REPRESENTATION

DA2017/039 - PROPOSED VISITOR CENTRE 3845 CRADLE MOUNTAIN ROAD, CRADLE MOUNTAIN

Image 1 – elevation profile from Cradle Mountain summit (left) to southern end of airstrip (right)

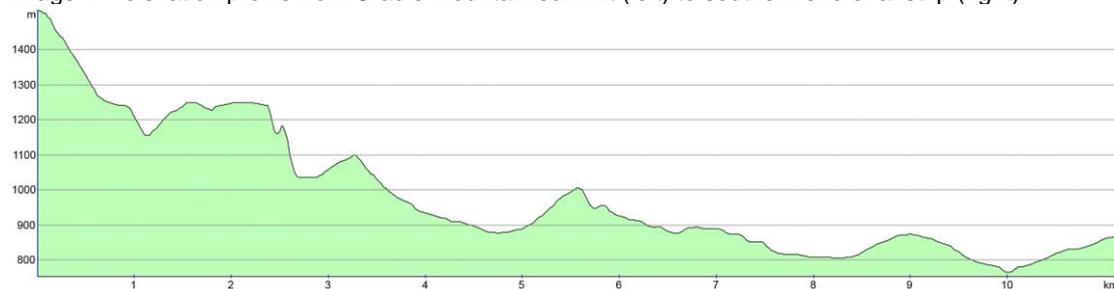
- The planning submission prepared by Emma Riley and associates (included in the DA) asserts (page 55) that “the buildings proposed and the development area will not be visible from the TWWHA”. This appears to be incorrect:

- There is no obvious blockage of the line of sight between the visitor centre and Cradle Plateau, or Cradle Mountain summit (refer Image 1 below).
 - The images provided in both the DA itself (Image 2) and the Cradle Mountain Master Plan (Images 3 & 4) show a clear expectation that the visitor centre will provide views of Cradle Mountain. It is self-evident that if Cradle Mountain is visible from the Visitor Centre, then the Visitor Centre is visible from Cradle Mountain.
